SUNDRY NOTICES AND REPORTS ON WELLS
Do not use this form for proposals to drill or to re-enter an abandoned well. Use form 3160-3 (APB) for such proposals.

8. Well Name and No.
CEDAR CANYON 20 FEDERAL COM 26H

OXY USA Inc. respectfully requests approval for the following changes from the approved permit:

OXY USA Inc. - Cedar Canyon 20 Federal Com 26H – Amended Drilling Plan

WELL LOCATION AND ACREAGE DEDICATION PLAT

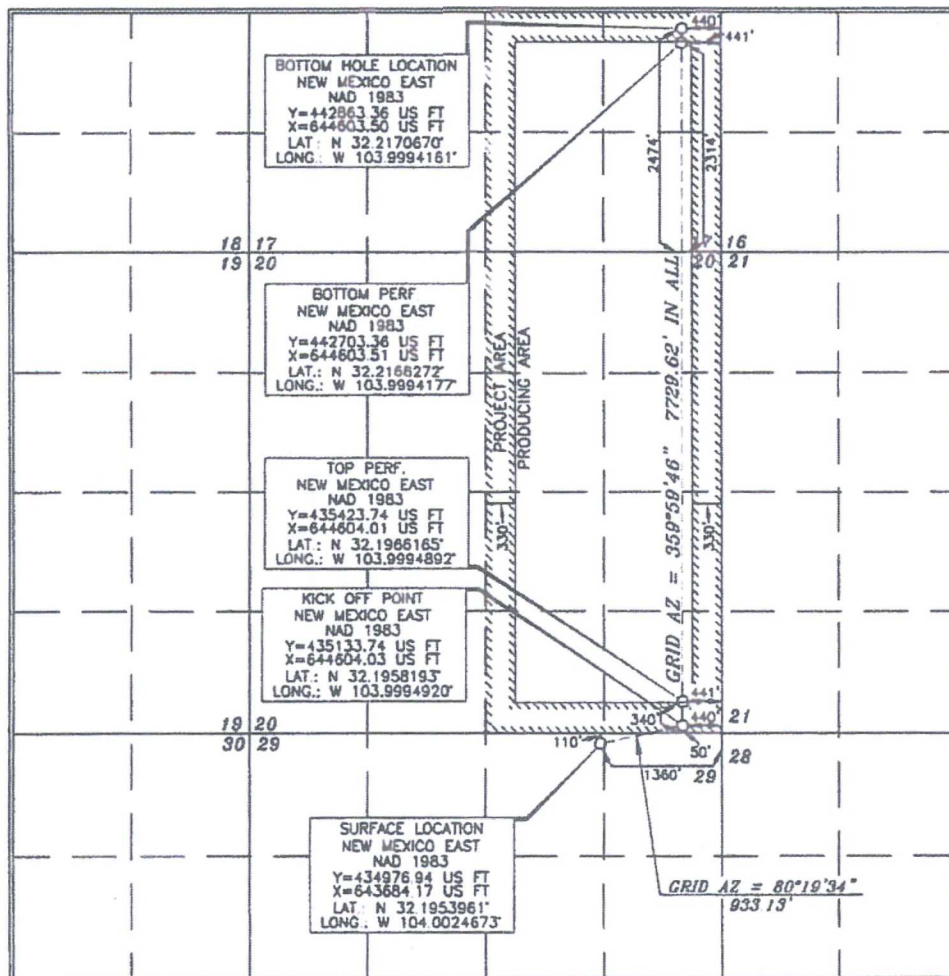
1. The horizontal lateral will increase to ~7500', amended C-102, directional plan and plot attached.

Surface - 110 FNL 1360 FEL NWNE 29-24S 29E - Lat. 32.1953961 Long. 104.0024678
KOP - 50 FSL 440 FEL SESE 20-24S 29E - Lat. 32.1958193 Long. 103.9994920
PPP - 340 FSL 441 FEL SESE 20-24S-29E - Lat. 32.1966165 Long. 103.9994892
Amd Exit - 2314 FSL 441 FEL NESE 17-24S-29E - Lat. 32.2166272 Long. 103.9994177
Amd BHL - 2474 FSL 440 FEL NESE 17-24S-29E - Lat. 32.217067 Long. 103.9994161

5M BOP Stack

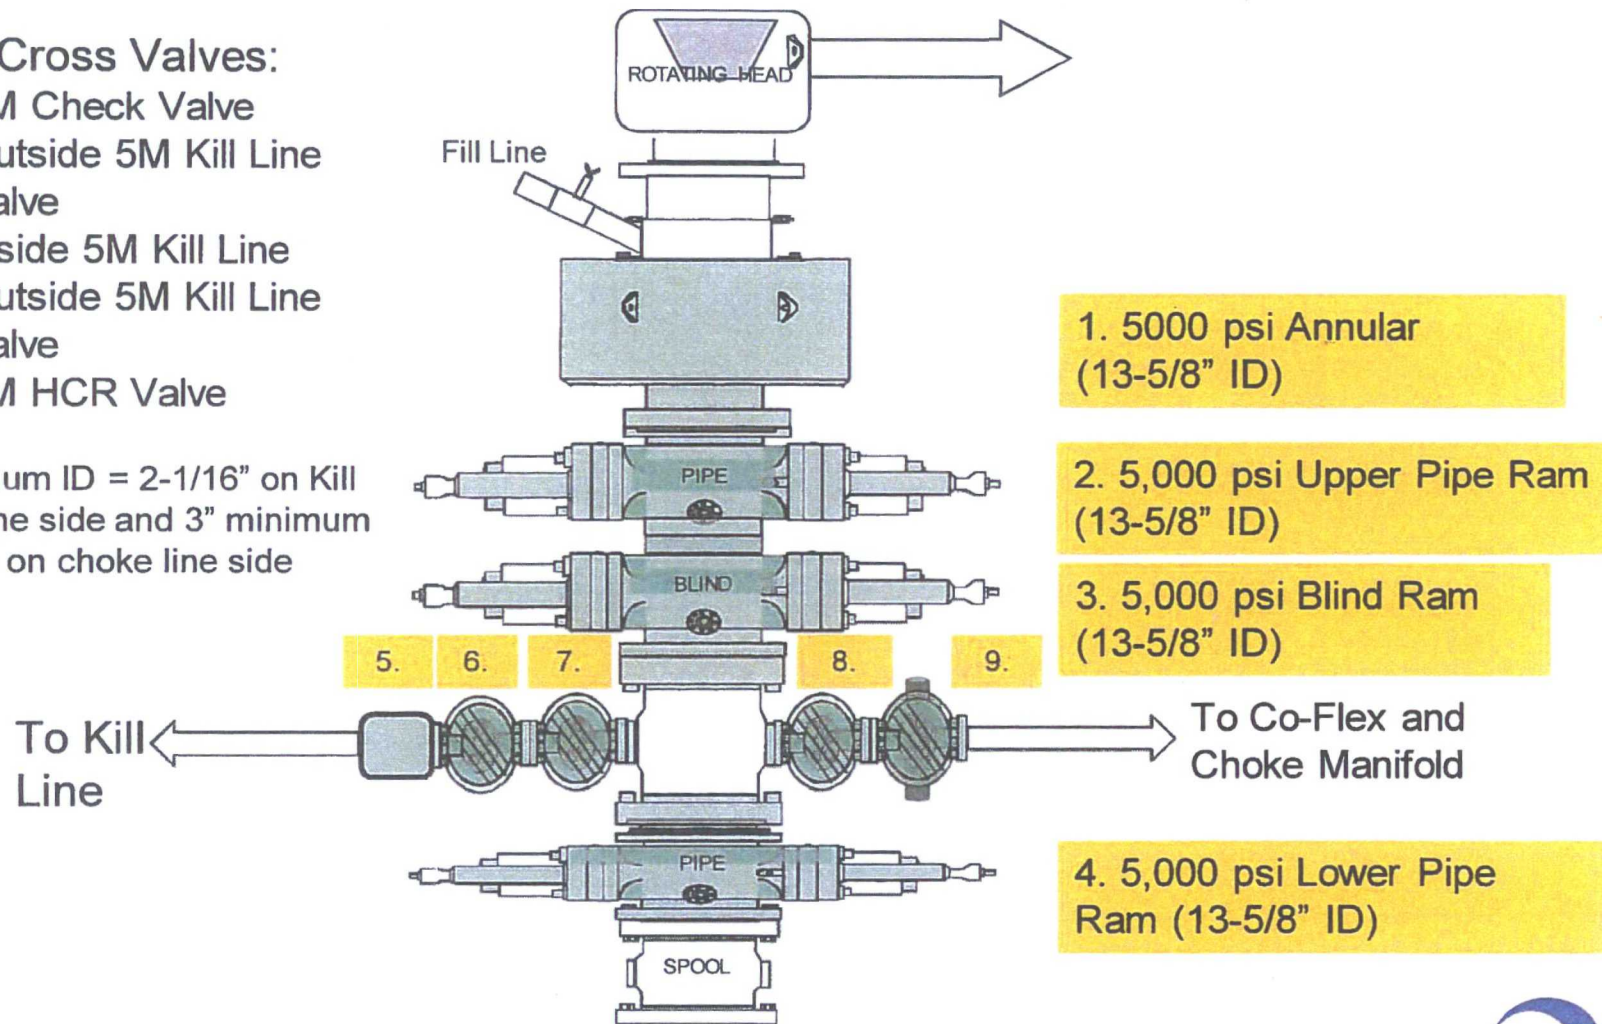
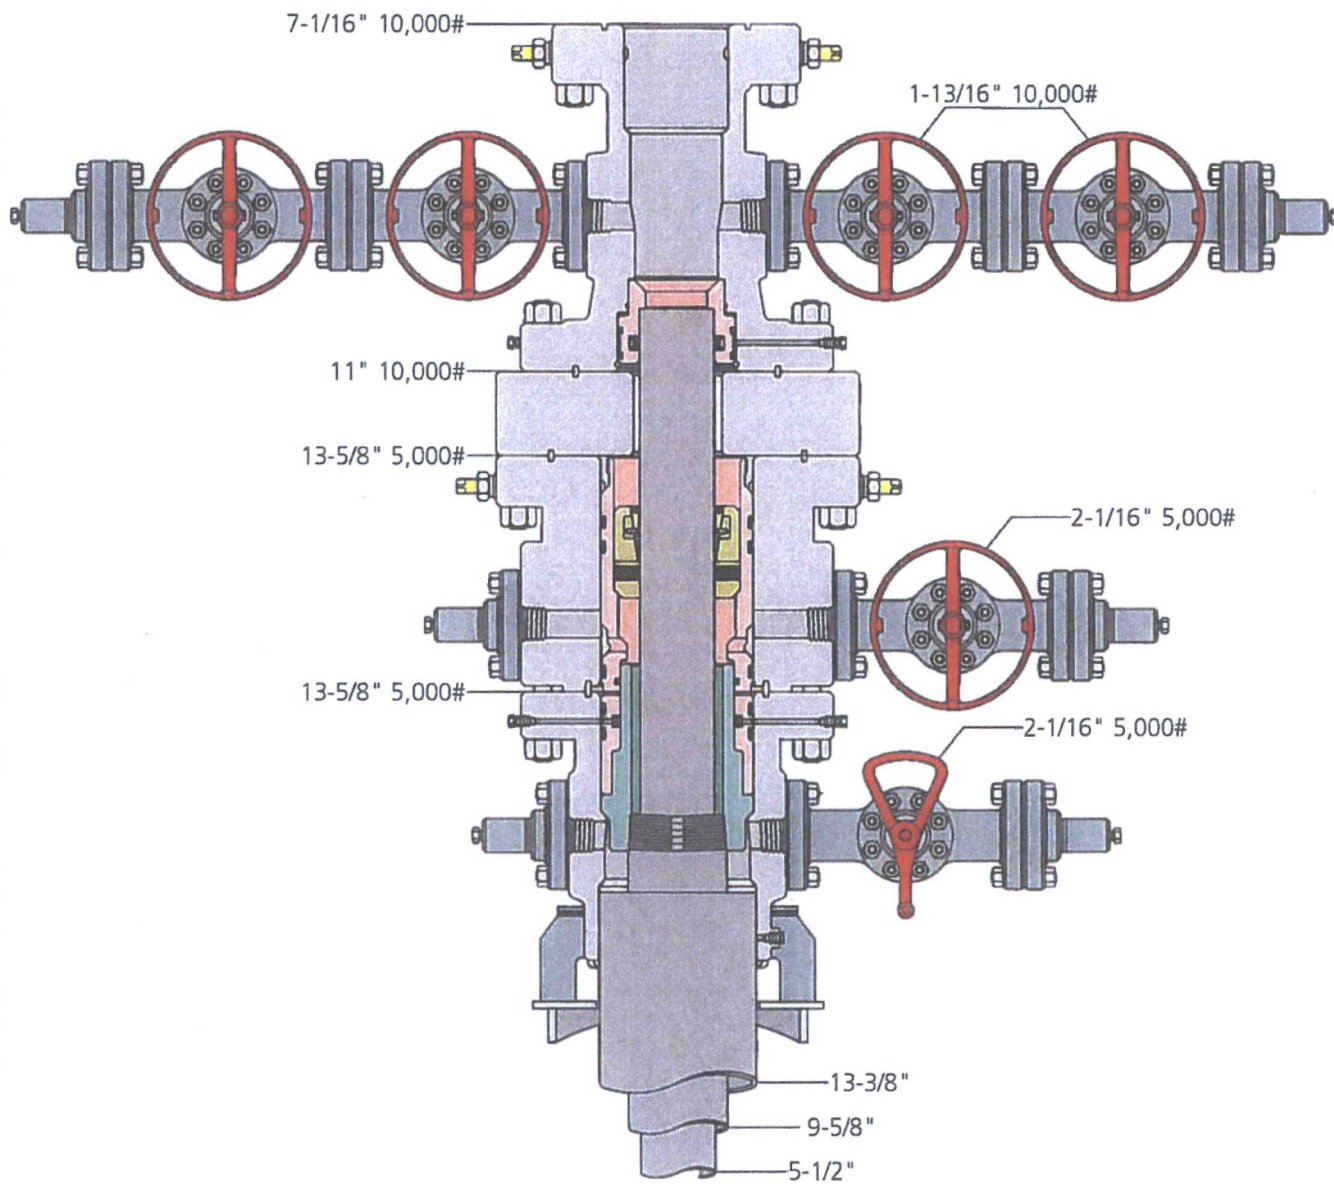
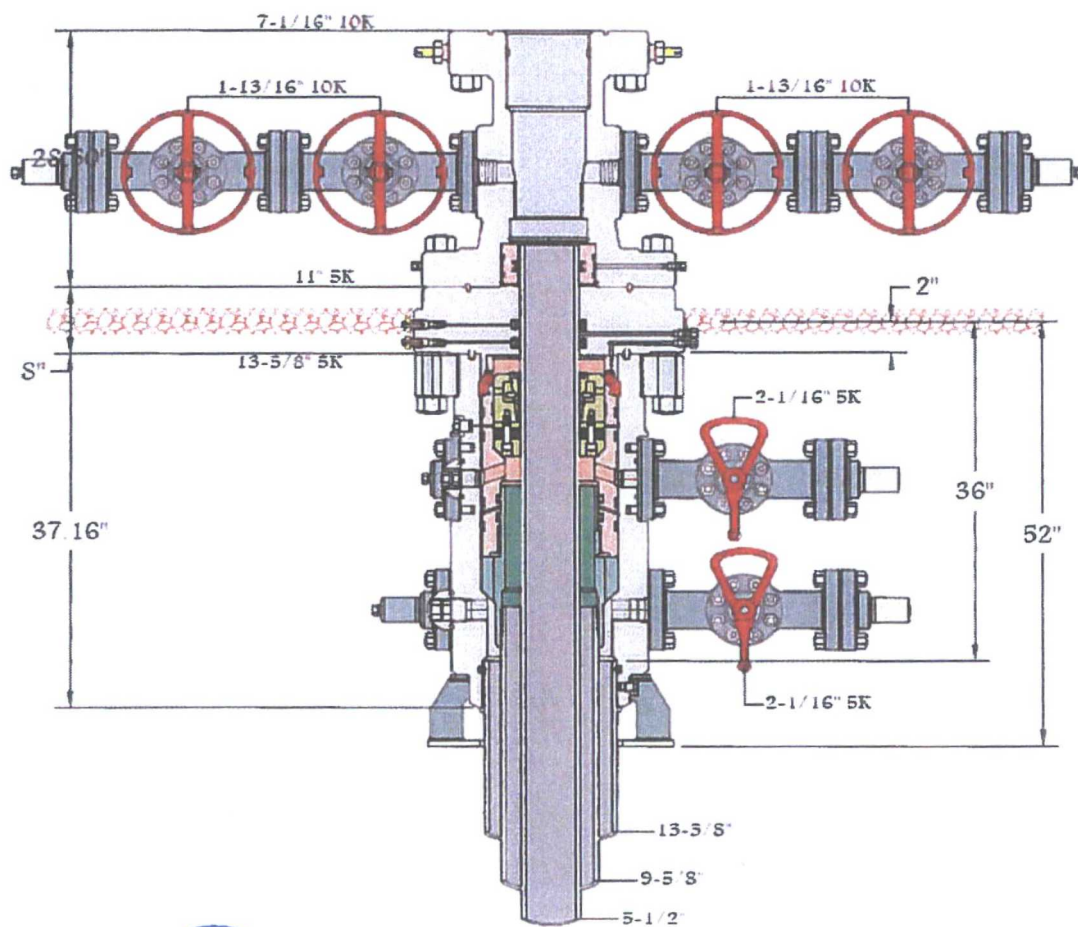
2. A multibowl or a unionized multibowl wellhead system will be employed. The wellhead and connection to the BOPE will meet all API 6A requirements. See attached for amended BOP diagrams.

3. 5M or higher system requires an HCR valve, remote kill line and annular to match. The remote kill line is to be installed prior to testing the system and tested to stack pressure.

4. If the operator has proposed a multi-bowl wellhead assembly in the APD. The following requirements must be met:
 - a. Wellhead shall be installed by manufacturer's representatives, submit documentation with subsequent sundry.
